THE COUNTY OF LENNOX & ADDINGTON

CONTRACT No. 24073

LOYALIST AMBULANCE BASE

ADDENDUM #4

Title:
Partial Cold Storage Foundation
Plan 1/S-7

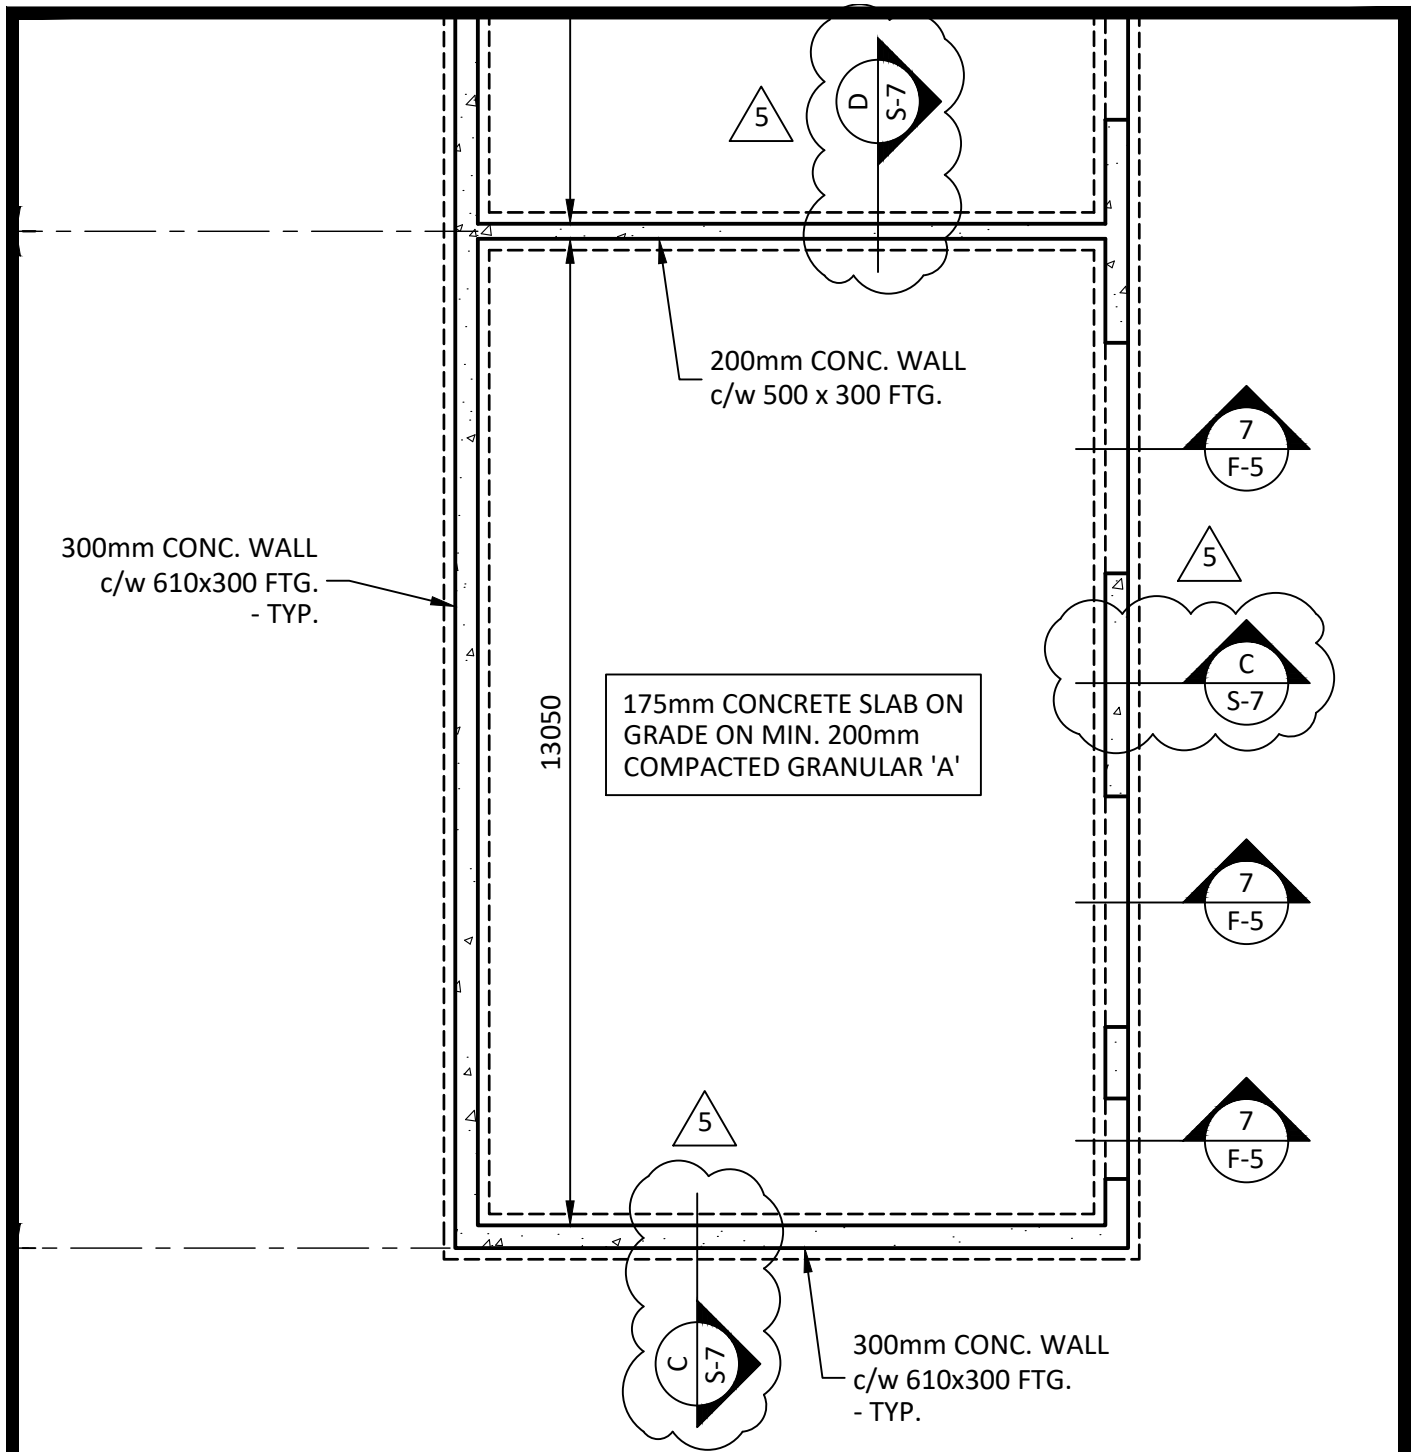
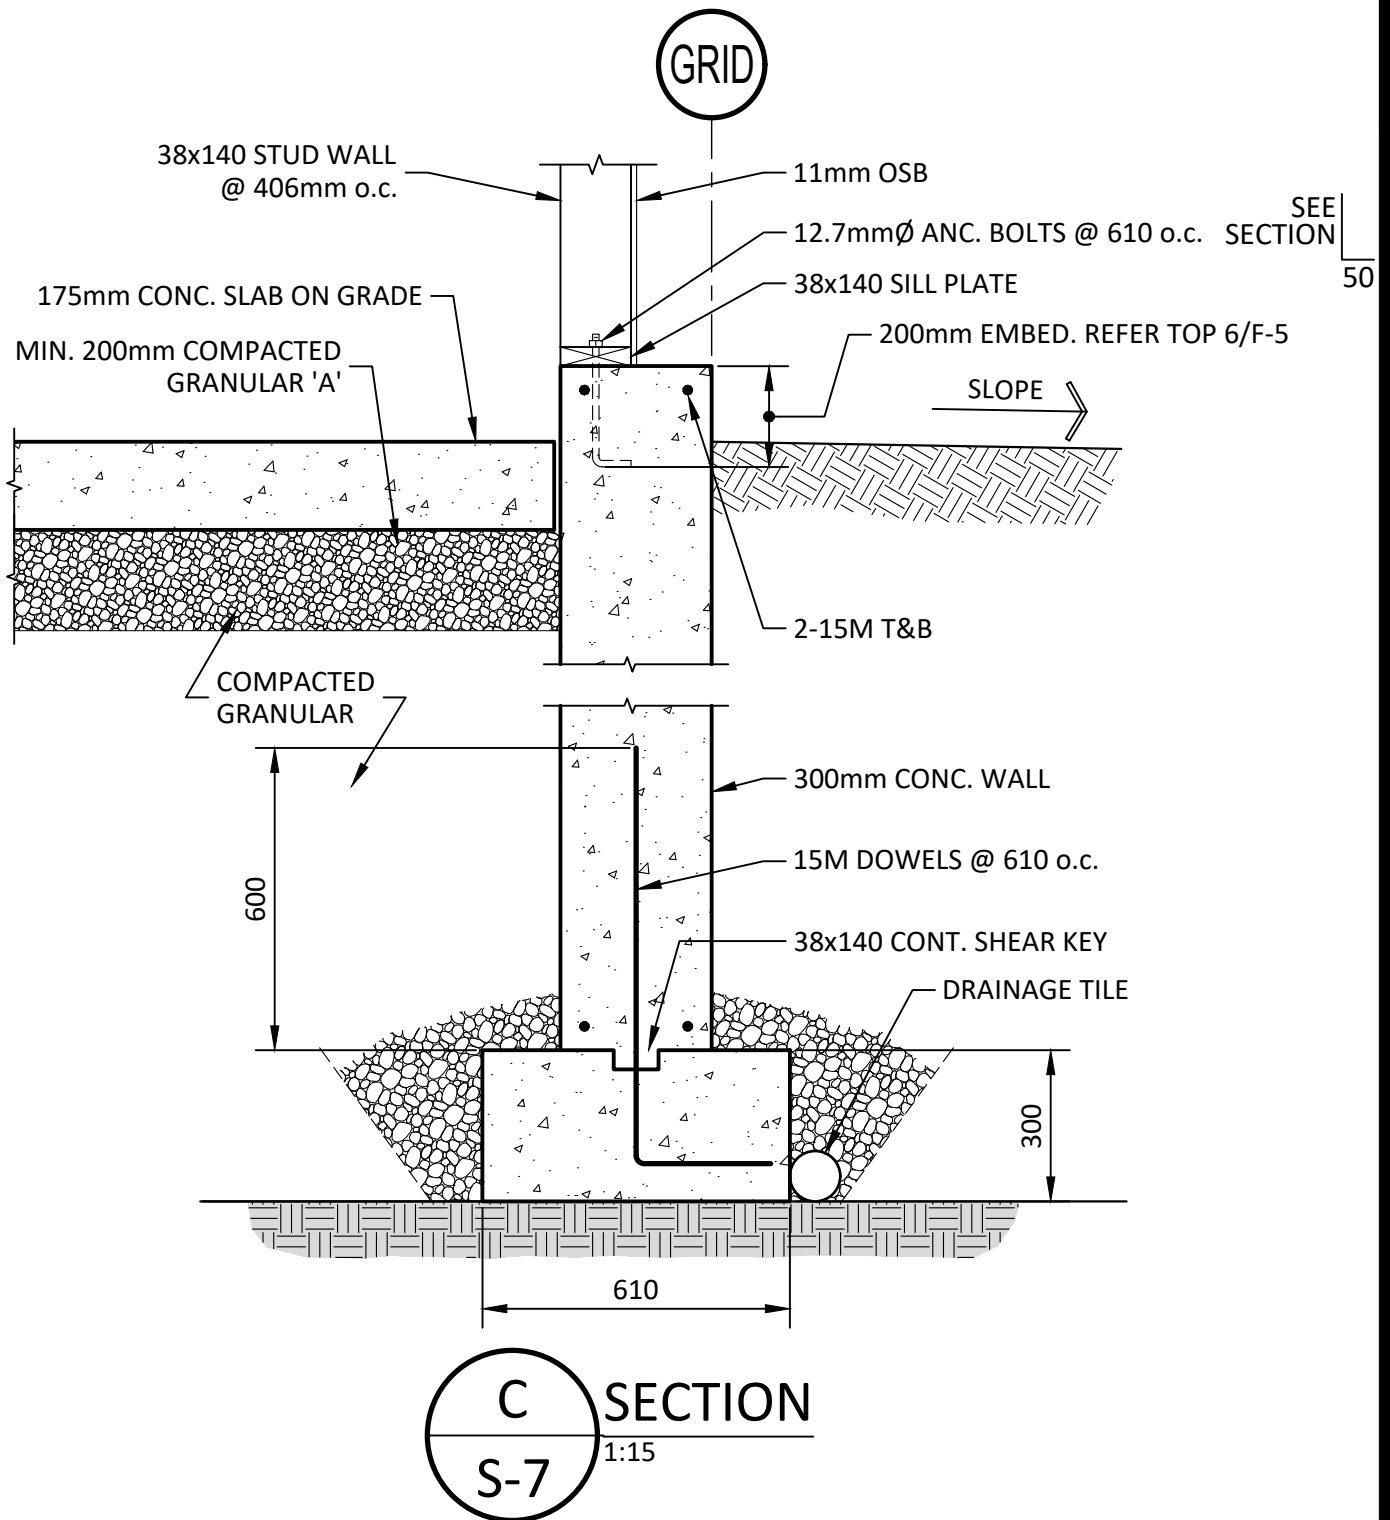
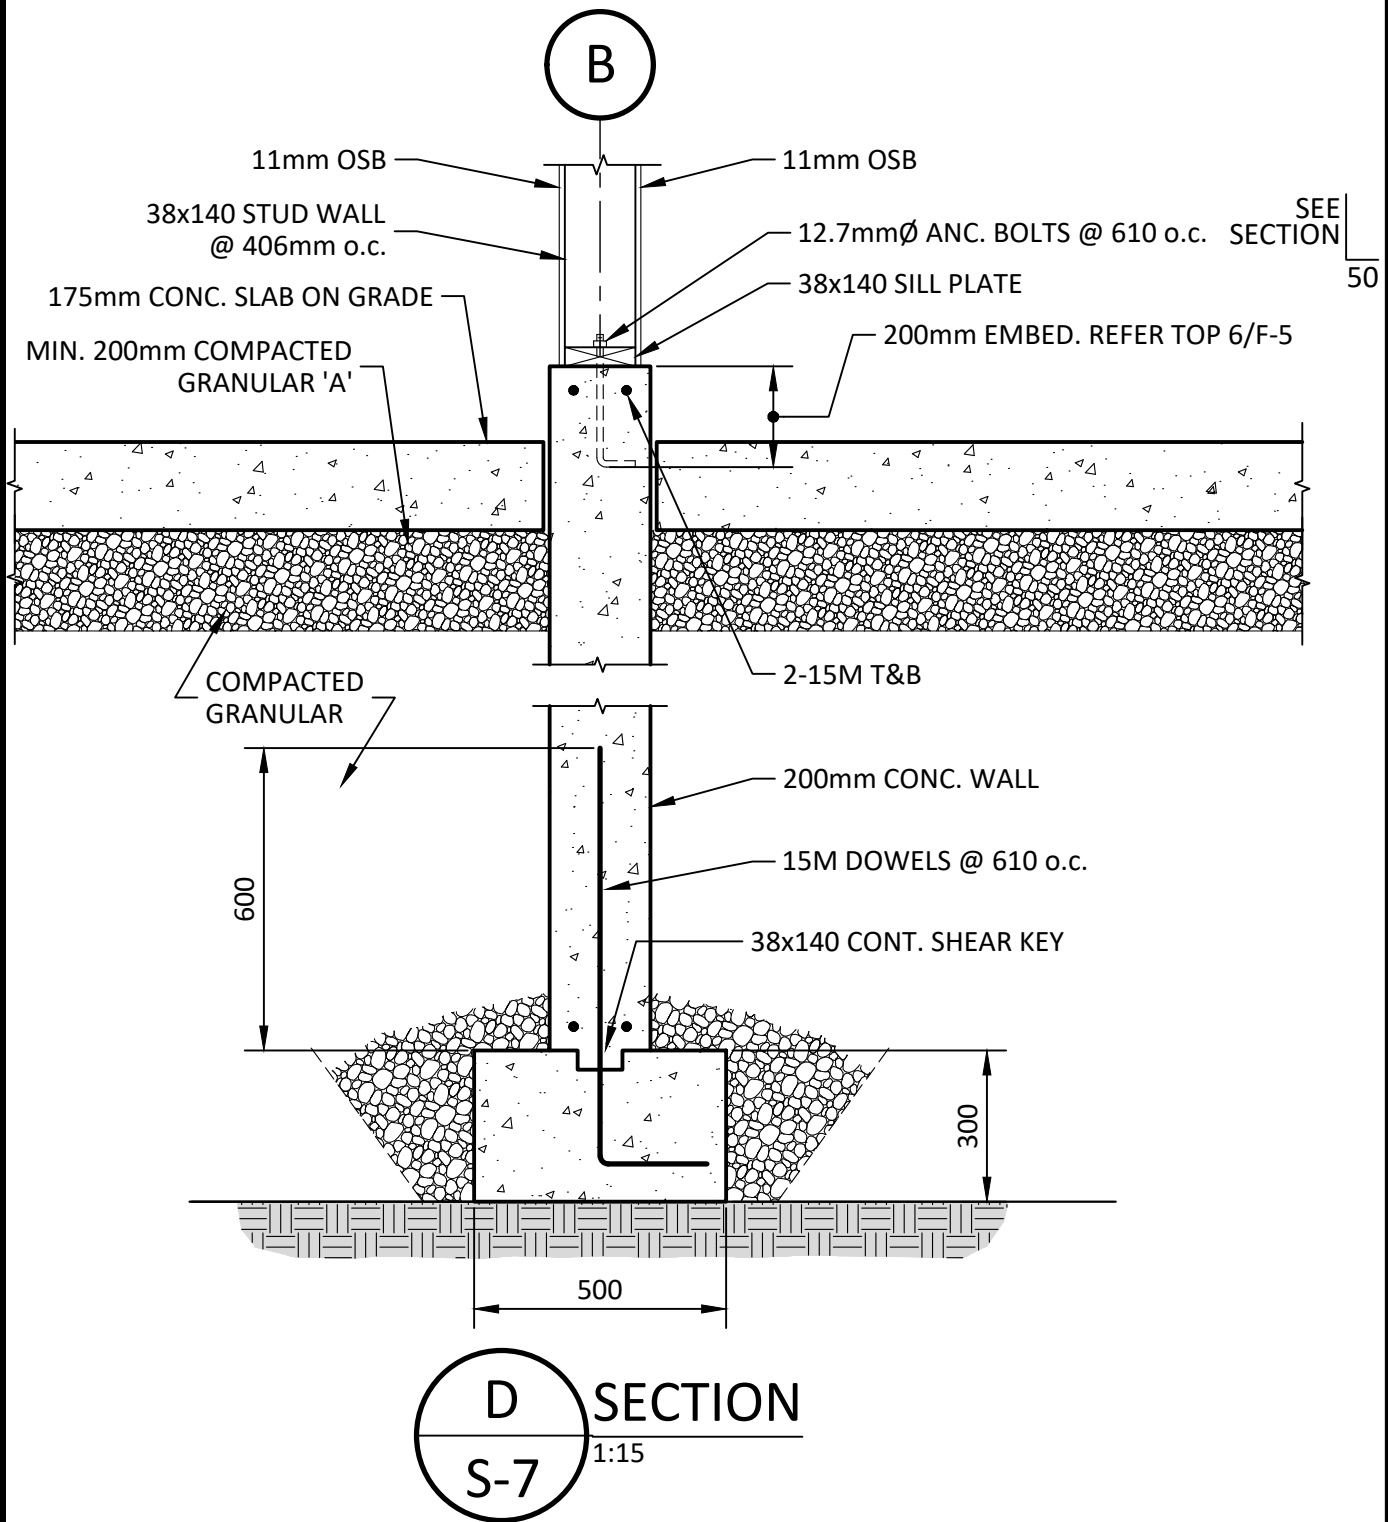
Q4: S-7 Detail number 2 says Anchor bolts for the front and middle foundation walls. Just want to confirm these are indeed for the foundation as they are only noted on the roof framing plan. No sill plate detail provided.

A4: Refer to attached sketches SK1, SK2, SK3, SK4 adding two new structural foundation wall section details at the cold storage building.

Approved by: K.K. Contract No: Drawing No: C-4

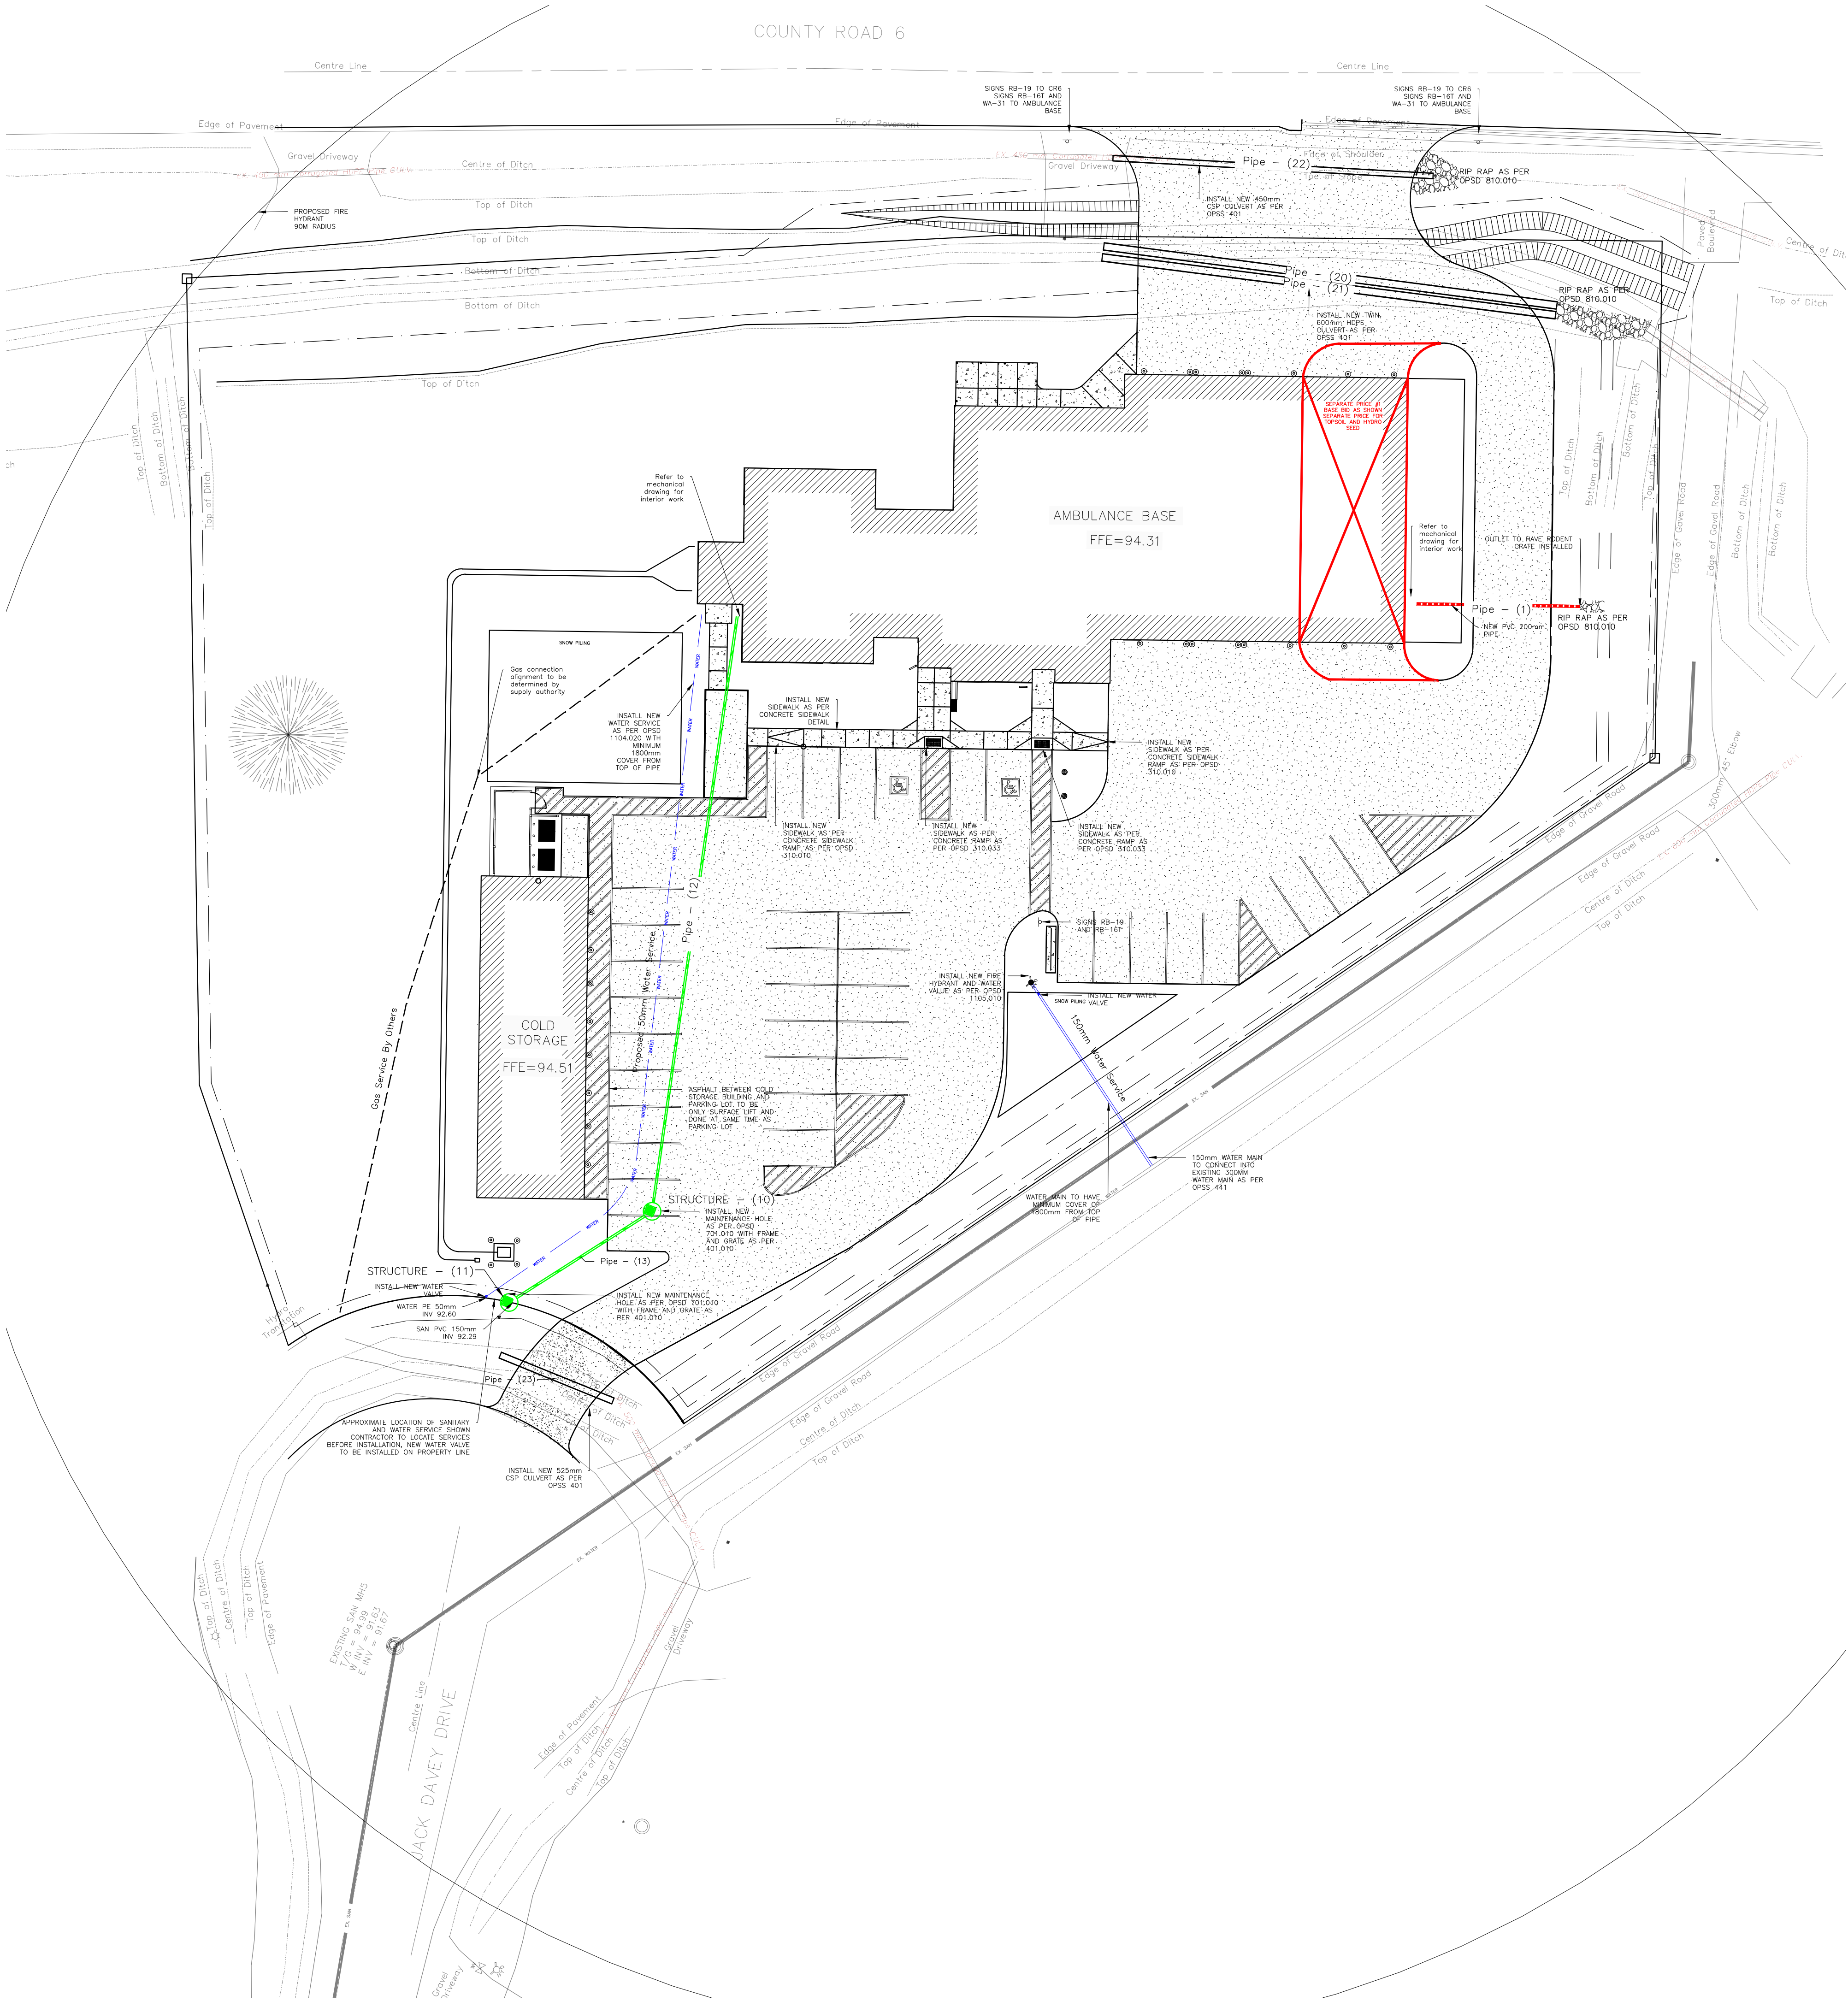
Refer to site plans on C-4, 101 and ES02. Shift the transformer/pad north about 3 m to avoid interference with water and sanitary lines as per updated drawing C-4 included.
